**HISTORIC ARCHITECTURAL REVIEW BOARD  
CITY OF ALLENTOWN, PENNSYLVANIA  
August 3, 2020**

**FINAL REVIEW**

**Address:** 248 N 10th Street

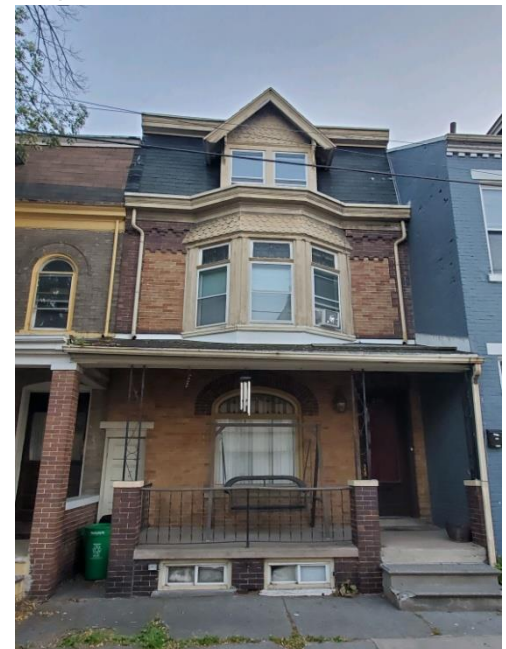
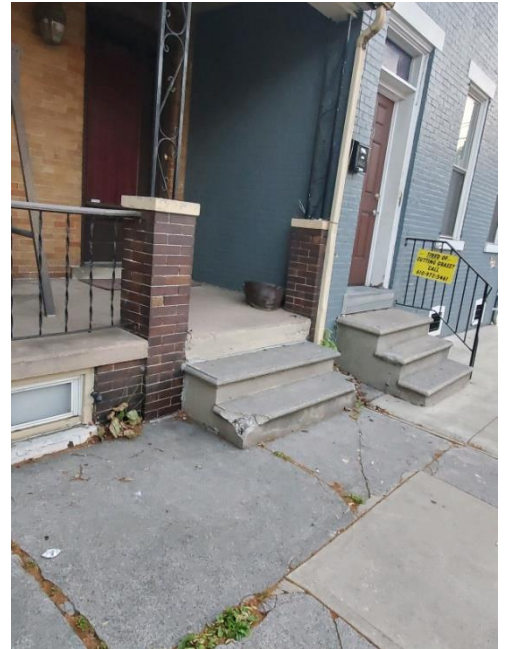
**Evaluation, effect on historic district, recommendations:** The proposed renovations are historically appropriate in approach:

- All transoms should be retained (which appears to be proposed). Replacement of double hung sash below the transom meets the local historic guidelines if the new windows match the existing windows in size and are aluminum clad wood as proposed. It is not recommended to cover the stained glass with storm windows.

- Replacing the existing Mansard roof with GAF Slateline shingles in Antique Slate color is historically appropriate. Replacement with slate, if budget allows, would be an ideal solution.

- Replacing the existing porch roof (currently appears to be 3 Tab shingles) with Slateline shingles, if the slope meets minimum required, is historically appropriate. Another option is Sarnafil membrane roofing with ribs to simulate standing seam metal roofing (or without ribs) in patina green color:

- 
- Replacing existing non-historic porch posts and railings with wood columns and wood railing is historically appropriate. Exact design on both needs to be determined. Submitted photo of turned wood balustrade and round Doric columns would be appropriate. Railing could also be simple square balusters of generous dimension and be historically appropriate.

- Existing K gutter on porch should be replaced with half-round gutter and round downspout. Color to blend with paint color of trim. Existing built-in gutter should be repaired and relined as needed

2. All five front windows will be replaced with aluminum clad 1 over 1 wood windows to fit the existing openings
3. The basement windows will be replaced with new hopper style windows to fit the existing windows

4. The stained glass transoms will be repaired and made weather tight. No storm panels will be placed over the transoms or living room window
5. The front and grocer alley doors will be restored

6. A full-light glass storm door in bronze aluminum may be installed over the front door
7. Address numbers will be placed in the front door transom
8. The Mansard and porch roofs will be replaced with GAF Slateline shingles in the Antique Slate color

9. The existing concrete porch steps will be replaced with bull-nosed concrete steps
10. Gutters and downspouts will be replaced with new half round gutters and round downspouts if needed

11. All woodwork will be repaired and repainted
12. The existing metal porch railings will be replaced with salvaged historic wood railings. The final railings must be approved by City staff

13. The existing metal porch columns will be replaced with Doric wood columns. The final selection must be approved by City staff
14. A new larger porch light will be installed with dusk to dawn light. The final selection must be approved by City staff.

**Address:** 215-217 N 11th Street --

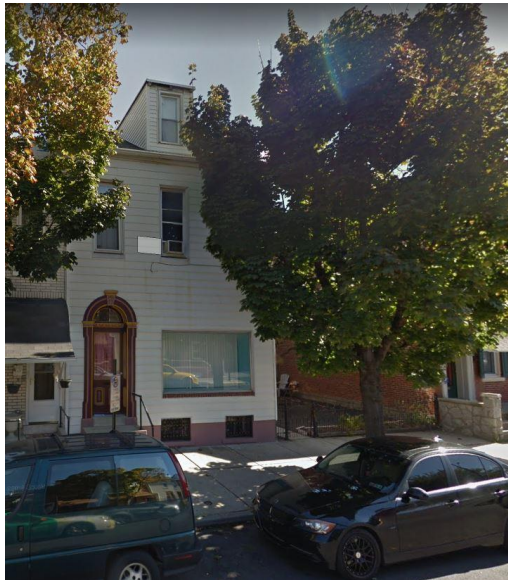
**Evaluation, effect on historic district, recommendations:** The proposed work is historically appropriate. Below are more specific comments:

- Removal of the aluminum siding on the front and side will improve the historic appearance of the house tremendously. Brick repair and repointing should follow Preservation Brief #2 recommendations and use soft mortar for pointing.
- It is recommended to use GAF Slateline roofing for the replacement for the main roof. Antique Slate color.
- Shutters (louvered) on the second floor would be historically appropriate. They should be appropriately sized to the opening.

1. The proposal to façade renovations at 215 N 11th Street was represented by Peter Lewnes.
2. The existing siding will be removed from the front. The condition of the brick or brickote will be assessed.

3. If brickote exists it will be painted or removed. If brickote removed the brick will be repaired and repointed as needed following Preservation Brief #2.

4. If front façade work is not too extensive, the siding on the side of the building will be removed and the existing brickote or brick treated in similar fashion to the front.

5. All front façade windows above the first floor will be replaced with aluminum clad 1 over 1 wood windows to fit original openings. New casing and cornice will be installed above the existing first floor windows or they will be replaced with new larger windows to fit the height of the original opening. New trim and casing would need City staff review and approval.
